CITY OF ALBUQUERQUE

**RE: The Preserve at Woodmont
Conceptual Grading & Drainage Plan
Engineer's Stamp Date: 05/17/21
Hydrology File: C09D015**

RE: The Preserve at Woodmont
Conceptual Grading & Drainage Plan
Engineer's Stamp Date: 02/26/21
Hydrology File: C09D015

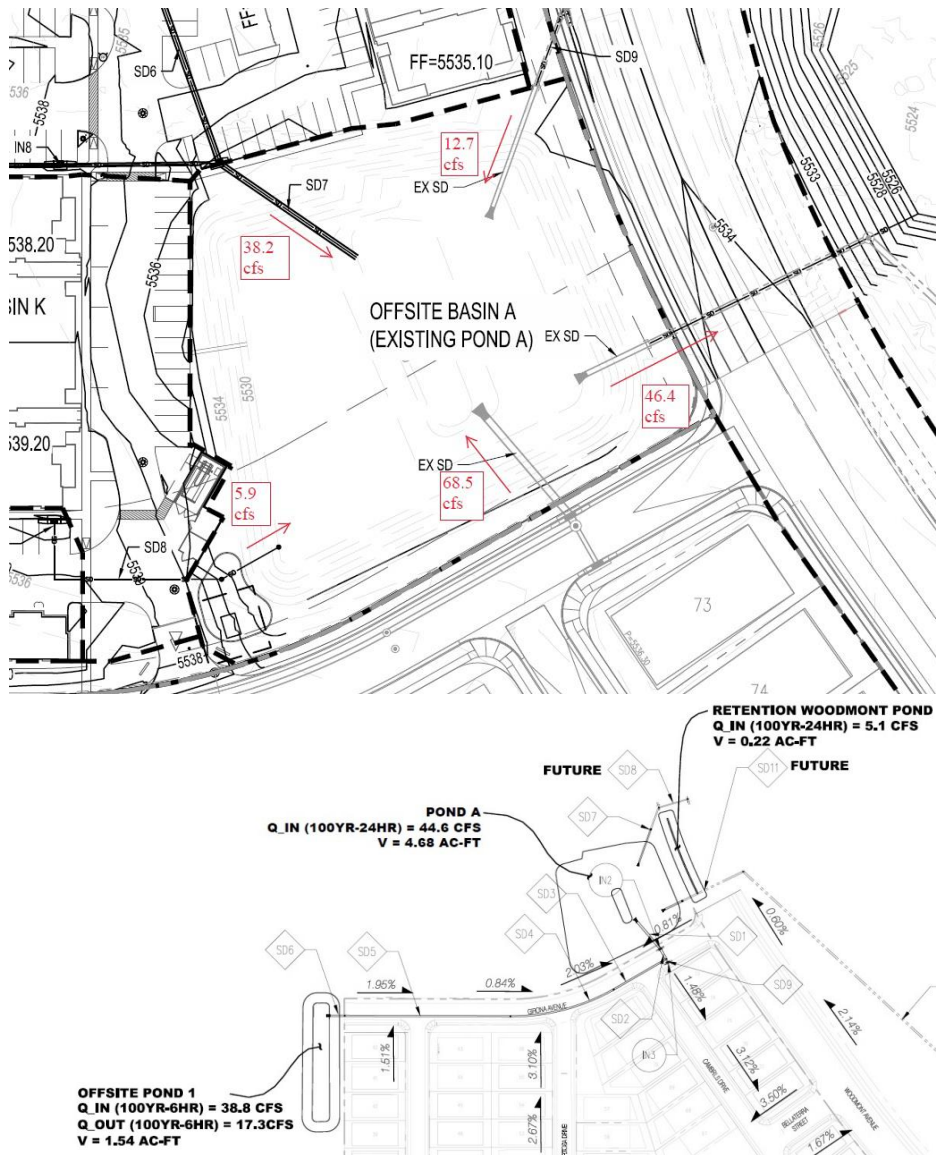
8. Based on the flows going into Pond A and the limited discharge out of the pond, it appears that Pond A was not designed to handle the flows that this project generates. (See the image below). Pond A was designed by the Drainage Report for Catalonia at the Trails Subdivision, dated March 25, 2020. It was designed to handle only 44.6 cfs (100 year-24 hr) or 4.68 ac-ft of volume. Please insure that this pond will function as designed. It appears that the Q entering Pond A is 56.8 cfs (from this DMP) plus 68.5 cfs (from Off-Site Pond 1, Catalonia Subdivision, and Girona Ave per the DR for Catalonia) for a total of 125.3 cfs with only 46.4 cfs discharging from Pond A. With these numbers, it appears that Pond A is not big enough.

Per our conversation, Pond A is designed to handle the flows coming from the new development as well as the flow from Woodmont and Catalonia subdivision. The addition of Offsite Basin D, in the interim condition, does not exceed the ultimate flows from Offsite Pond 1. Therefore, the addition of Offsite Basin D does not exceed Pond A's capacity. In the ultimate condition, Offsite Basin D will no longer be conveyed through our site as described in comment response #4.

An abbreviated sensitivity analysis was done to compare the pond routing schemes in HEC-HMS (v4.2) and EPA SWMM (v5.1). In SWMM, the sensitivity analysis was limited to evaluating the 'Pond A' hydraulics and downstream routing to 'Pond A5' and comparing those results versus those that were produced using HEC-HMS. In our best engineering judgement, the differences between the two software models are considered minimal and within the acceptable tolerances for a hydrologic analysis. The minor differences are due to how each program models or can model the outlet structure. In the first HMS scenario, the outlet is modeled using the FHWA HDS No. 5 culvert charts that allow for varying flow regimes, headwater, and tailwater conditions. The SWMM model uses an orifice outlet to model the pond discharge and results in very comparable pond performance. The second scenario in HMS utilizes a simple orifice outlet (similar to SWMM) and again produces very comparable results.

The evaluation of SD-1 shows that the HEC-HMS routing methodology (Muskingum-Cunge) produces nearly identical results from SWMM's methodology (Kinematic Wave). Both show minimal effects from on-site routing and do not impact the routing of the various pond hydrographs as they are managed through the site during large storm events.

**CONCEPTUAL
GRADING AND
DRAINAGE PLAN**

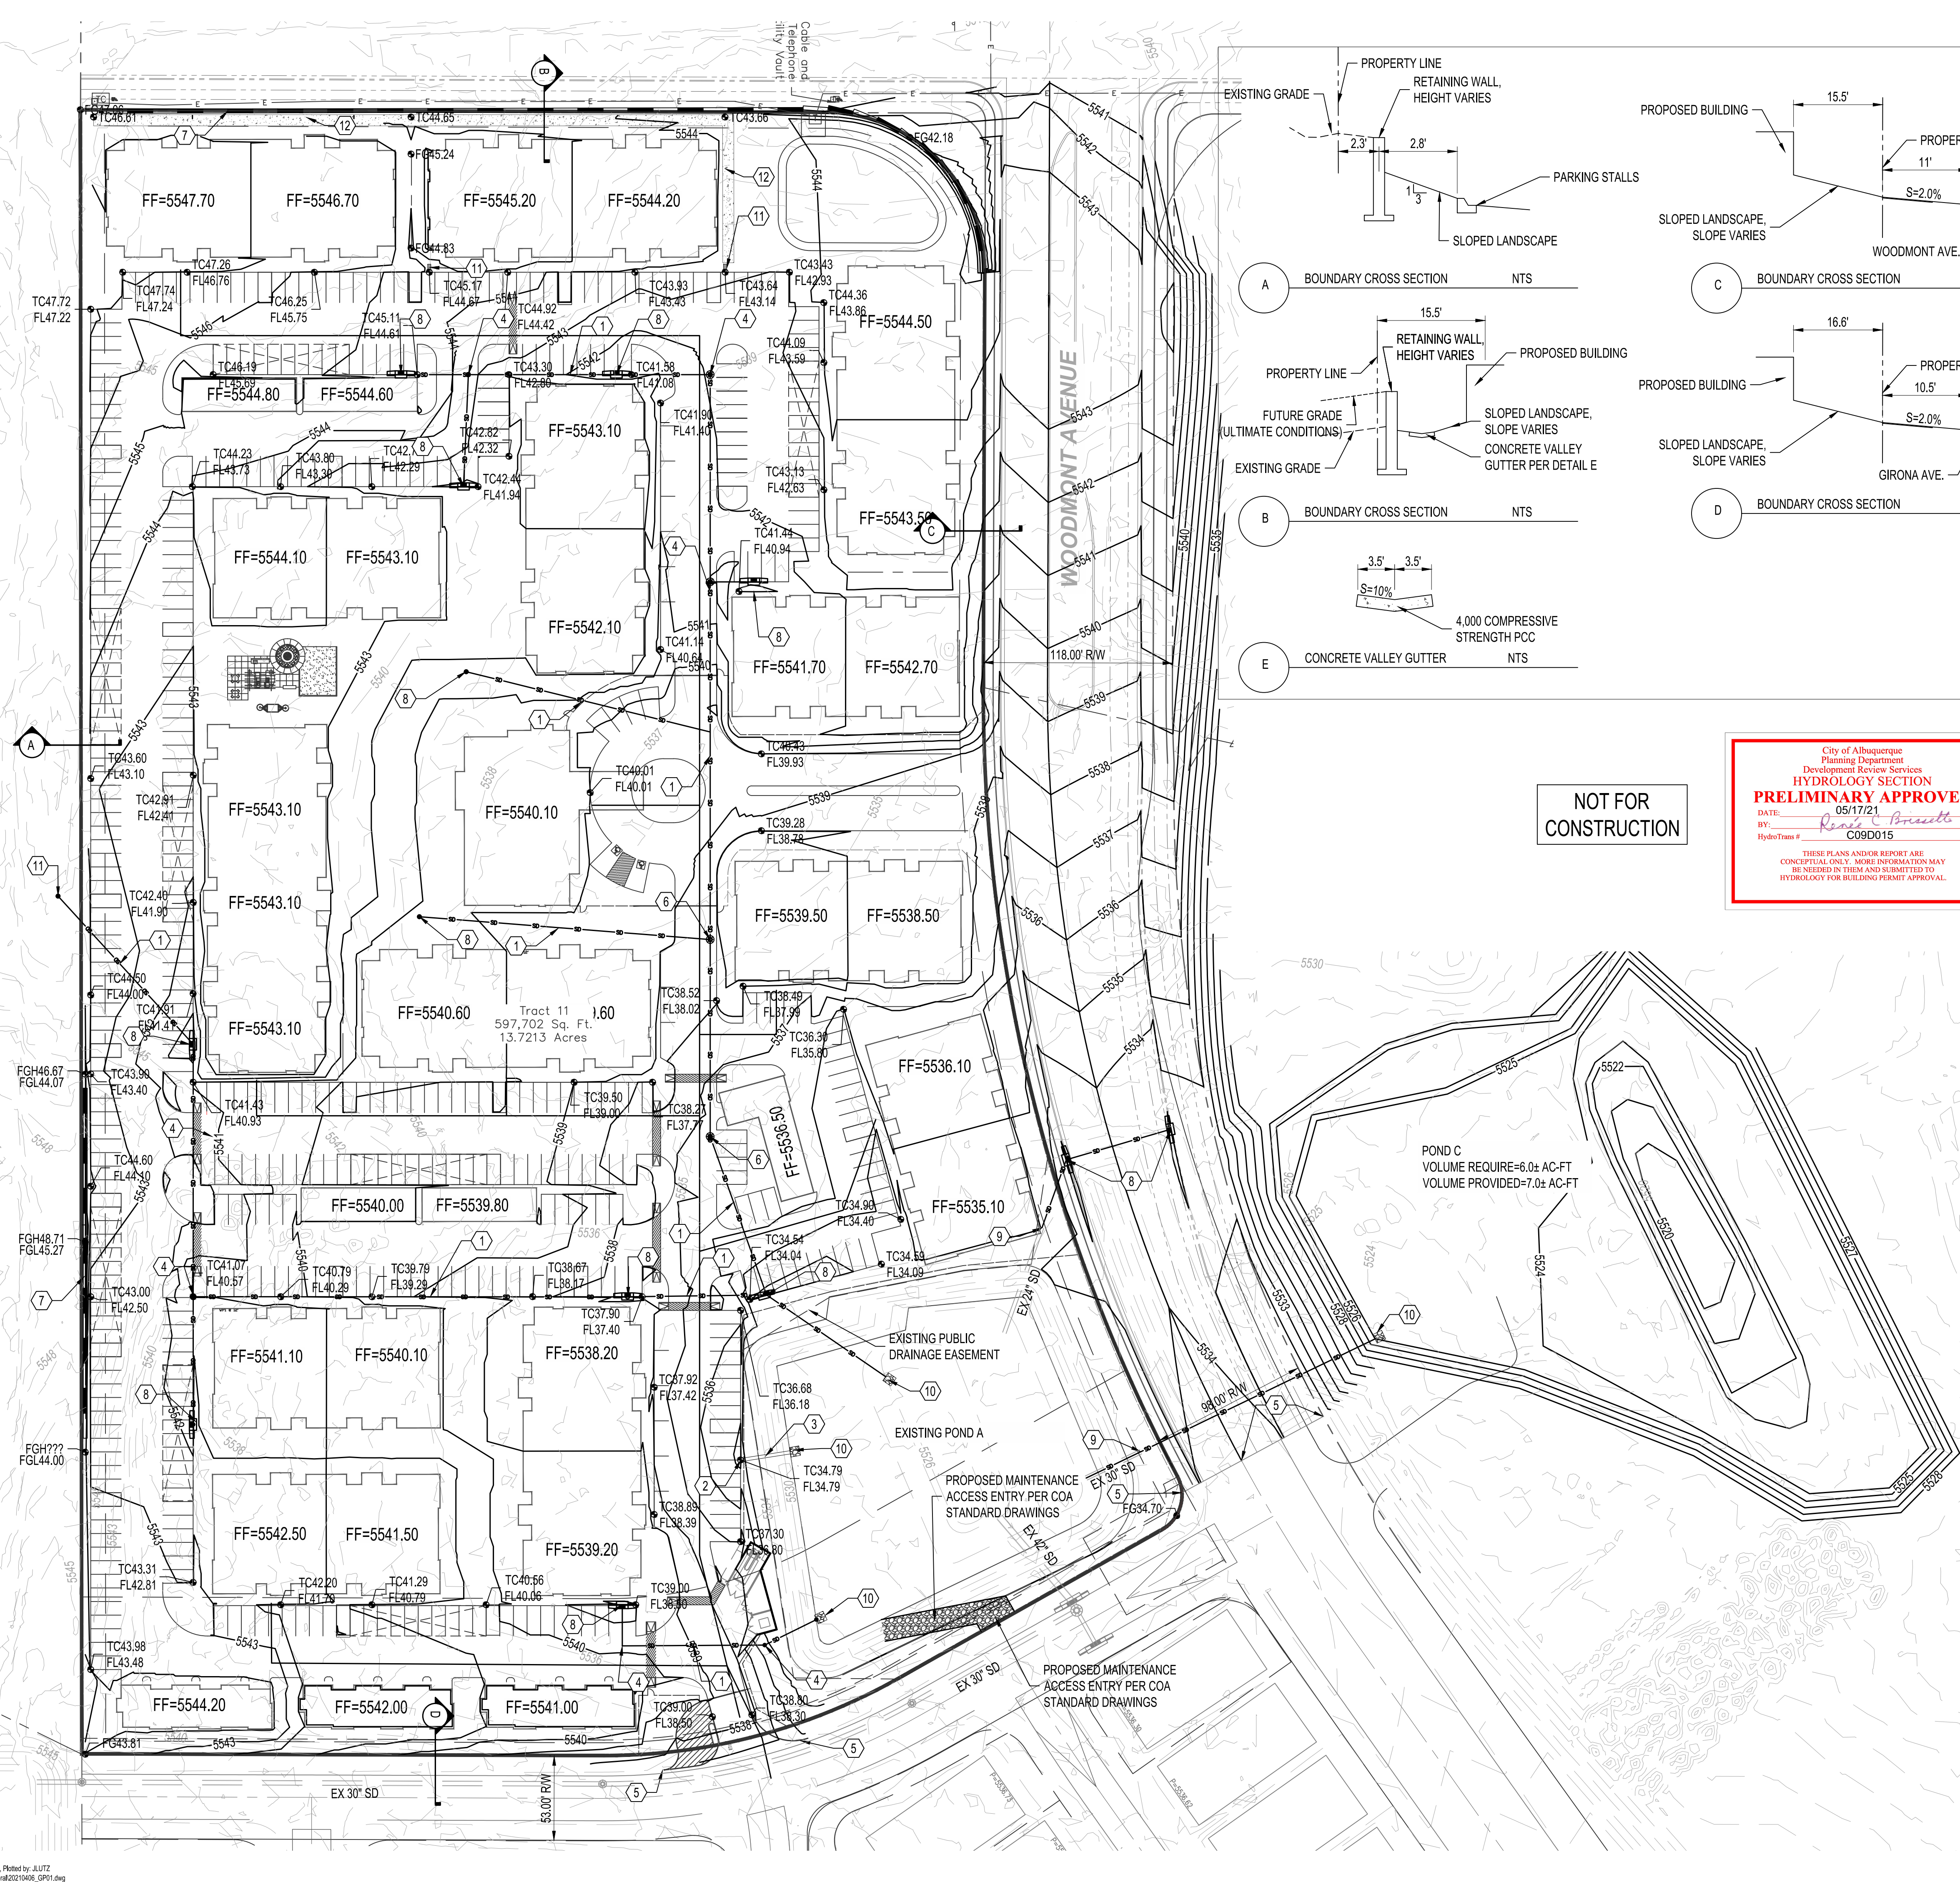
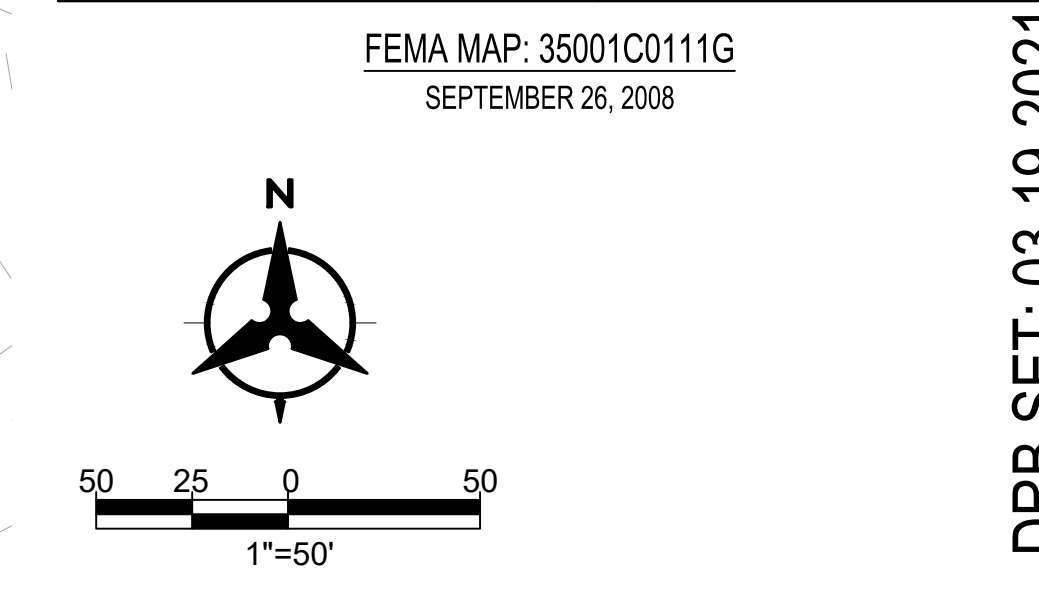
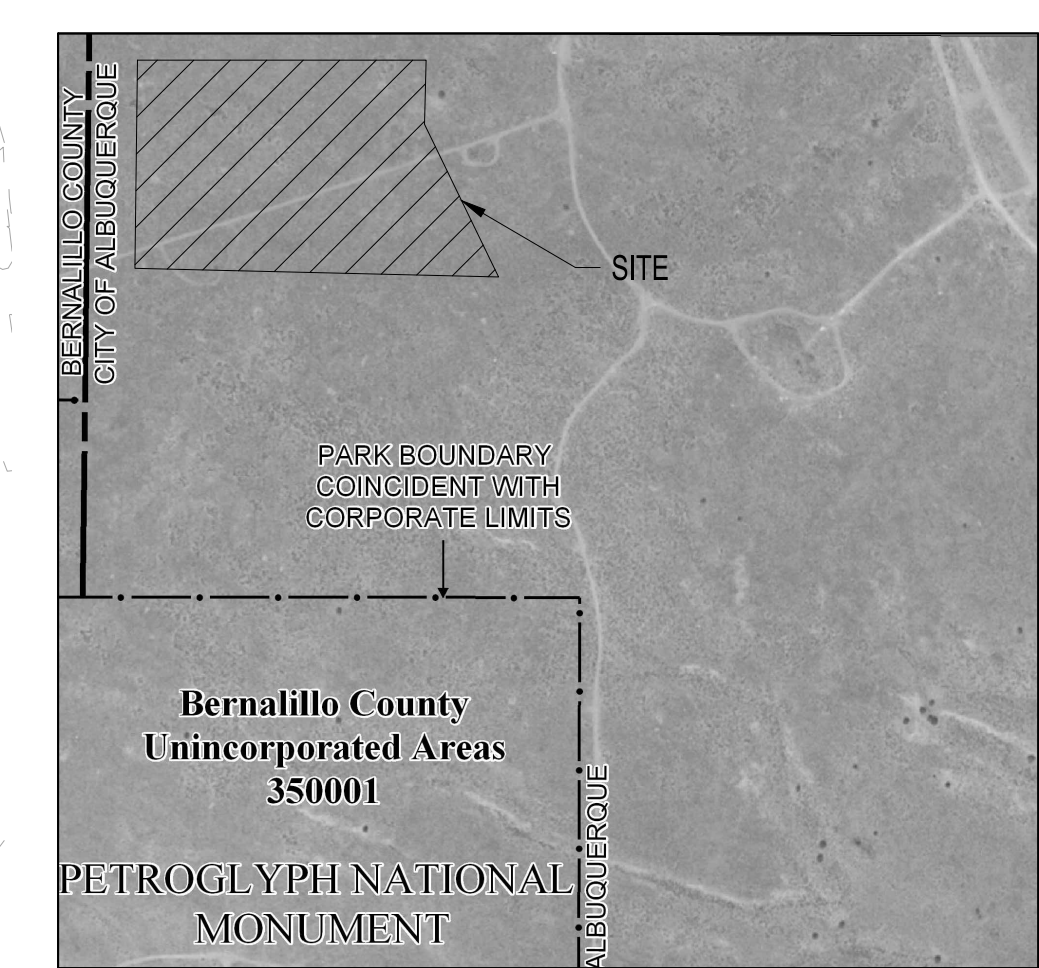
2. Section B shows a small portion of the site along the northern property line being graded to Paseo del Norte R.O.W. Currently it appears that Paseo is higher than the natural grades at the shoulder and the runoff appears to actually discharge into the site. (see photo below) How is this new discharge from the site and the existing runoff from Paseo being handled? Please note that any work within Paseo del Norte R.O.W. will have to be approved by New Mexico DOT. This can be done prior to work order approval.

3. This project is proposing to install the intersection of Woodmont and Paseo del Norte. How is the runoff from Comment #2 going to cross this intersection? Is there going to be a culvert installed? Please note that any work within Paseo del Norte R.O.W. will have to be approved by New Mexico DOT. This can be done prior to work order approval and be included on the Infrastructure List.

4. Section A. It appears that there will be off-site drainage from west watershed that enter the site and the proposed retaining wall will then work as a broad crest weir for this runoff and it will then enter the parking lot of the project. Has this been accounted for in your design? Or are you planning to provide a swale to collect the runoff and have it discharge into Girona Ave. Please address the off-site flows.

A retaining wall has been added so the site will not discharge to Paseo. Paseo del Norte will convey drainage as it has historically.

As we discussed, the drainage from Paseo will pond west of Woodmont and it will eventually overtop the curb in larger storms and continue across the intersection. This is similar to how the interim Rainbow/Paseo intersection has been designed.

The drainage from Offsite Basin D will be conveyed via a drop inlet and is accounted for in the storm drain network design. This is an interim condition and once Offsite Basin D is developed, the storm drain will be plugged, and this will no longer be an acceptable discharge point for that area. With the development of the site, Offsite Basin D will need to convey their drainage to the storm drain network located in Girona avenue and adhere to the allowable discharge provided by the Catalonia Drainage Management Plan.

**CONCEPTUAL
DMP01**

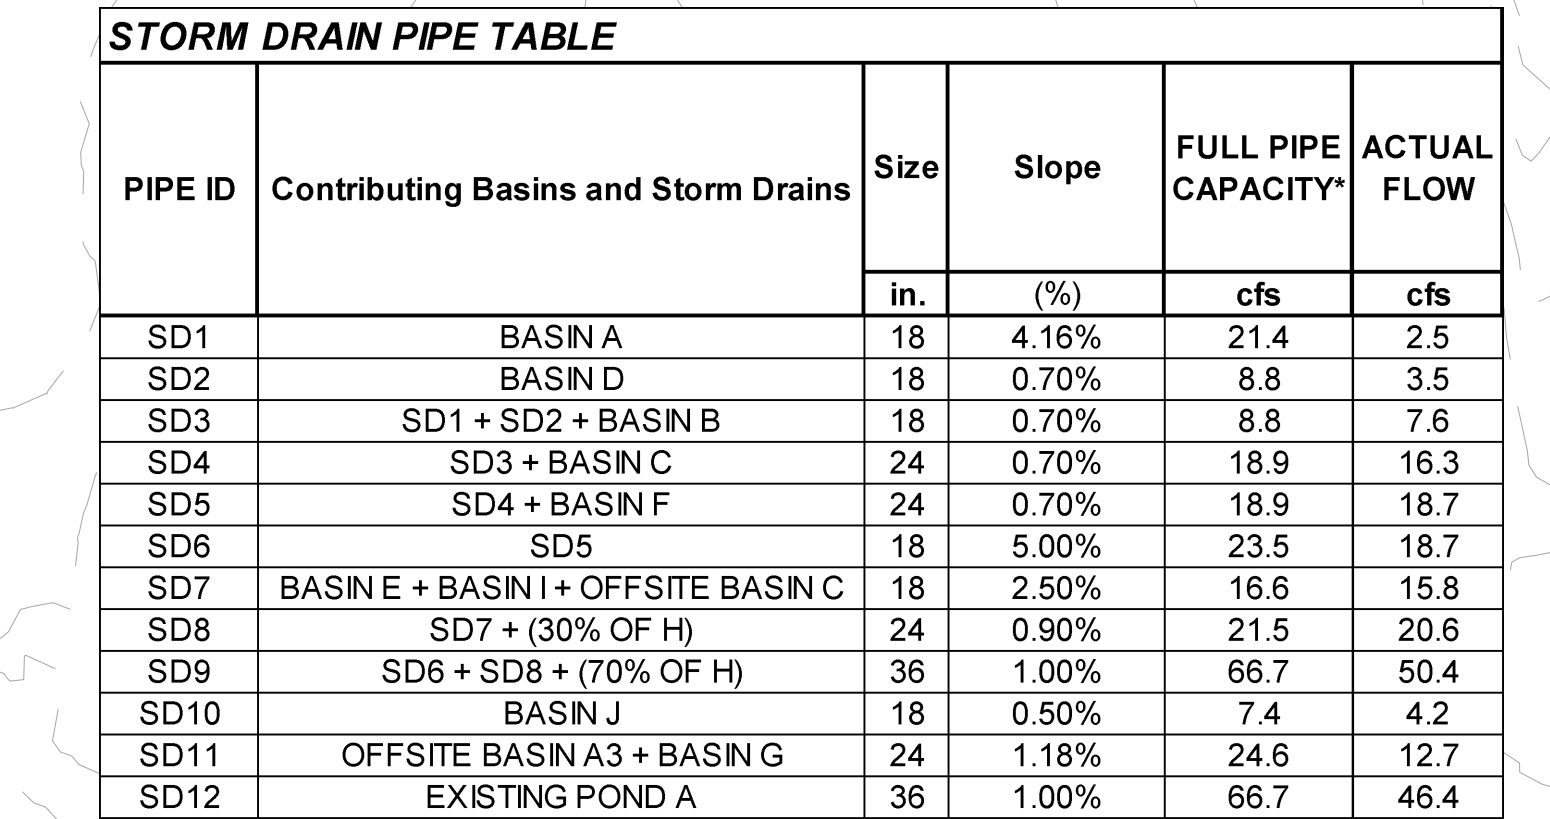
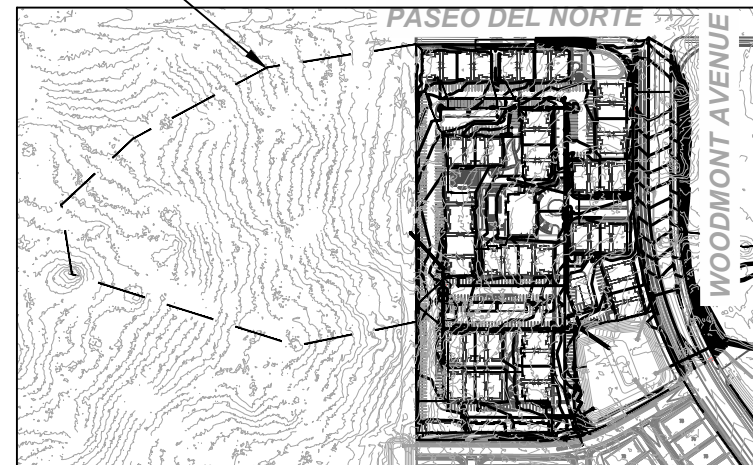
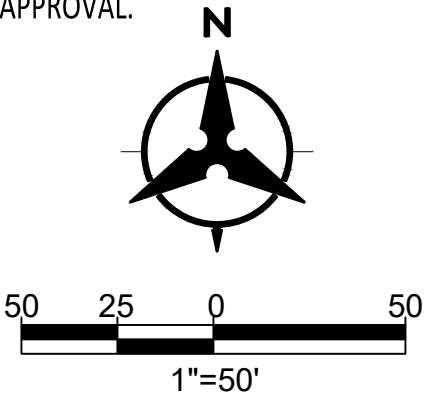
5. Please fix Basin A, B, & C to reflect the drainage that is entering Paseo del Norte R.O.W. (See Comment #2) This should be shown as an additional Basin.

6. Please fix Basin C to reflect the drainage that is entering Woodmont R.O.W. This should be shown as an additional to the Woodmont Basin.

7. A new off-site basin should be shown to address the drainage from Comment #4. Also, please note that this drainage was not addressed in the road and drainage system that was designed by the Drainage Report for Catalonia at the Trails Subdivision, dated March 25, 2020.

The site will not discharge to Paseo del Norte.

Basin G has been updated to include the additional runoff from the site to Woodmont.

Offsite Basin D has been added. It is shown in an overall map due to the scale.
